DNR File No. DC-0070

Subject: Amendment of the *Dane County Water Quality Plan*, Revising the Central Urban Service Area Boundary and Environmental Corridors in the Village of Deforest

Resolution RPC No. 1033

Amending the *Dane County Land Use and Transportation Plan* and *Water Quality Plan*, Revising the Central Urban Service Area Boundary and Environmental Corridors in the Village of Deforest, Dane County

**Map 1 Amendment
to the Central
Urban Service Area,
Village of DeForest**

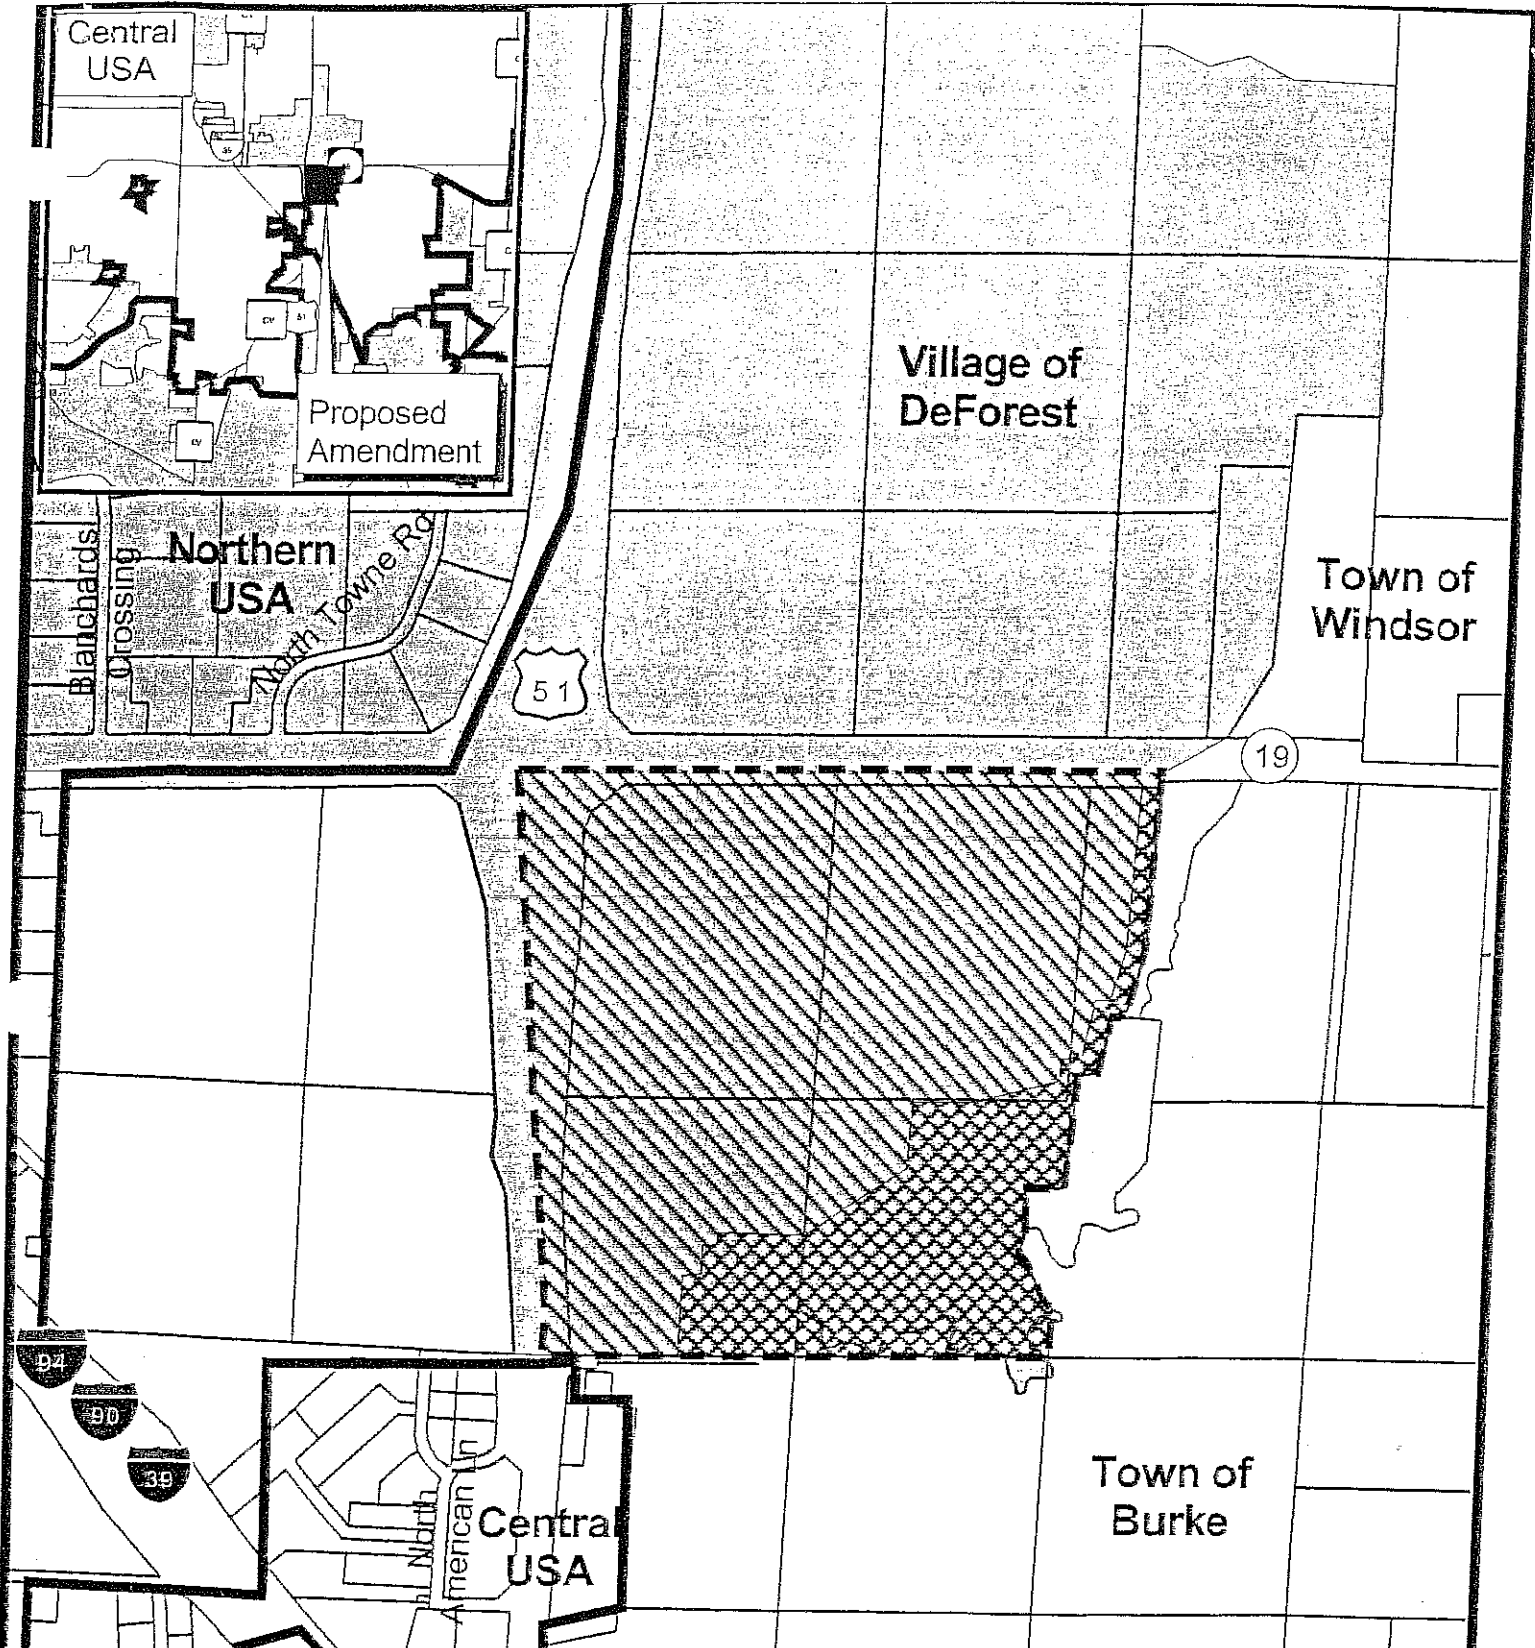
We have completed our review of the subject amendment request that was submitted to the Department on October 11, 2004 from the Dane County Regional Planning Commission. The Department hereby conditionally approves this amendment request that adds 192.0 acres to the Central Urban Service Area, including 45.3 acres of environmental corridors and 126.7 acres of developable land. The amendment area is located adjacent to State Highway 19 on the north and U.S. Highway 51 on the west, within the Village of Deforest. See Map 1 of Attachment.

2. Designate all open space areas, stormwater management areas, 75-foot wetland and shoreland buffer areas, and the buffer for the tributary along the east border of the amendment area as environmental corridors.

3. Increase the upland buffer for the tributary along the east border of the amendment area to 200 feet, especially where the tributary bows to the west and along the old carp pond.

1. Submit a detailed stormwater plan for DCRPC and DCLCD staff review and approval prior to development. Stormwater measures should include the following:
 - Construction phasing to prevent unnecessarily large areas of exposed and disturbed ground.
 - Stormwater quality management practices to provide 80% sediment removal for up to a 5-year storm event.
 - Infiltration practices to provide 82.6 acre-feet of infiltration per year to mitigate the impacts of groundwater withdrawal and diversion.

- Infiltration practices to mitigate the impacts of lost recharge due to impervious areas, based on a detailed and quantitative assessment of the extent of groundwater recharge from the site in its present (agricultural) state.

- Stormwater quantity management practices to maintain pre-development rates of runoff for all storms up to and including the 100-year storm.
 - Install stormwater quality ponds prior to other land disturbance.
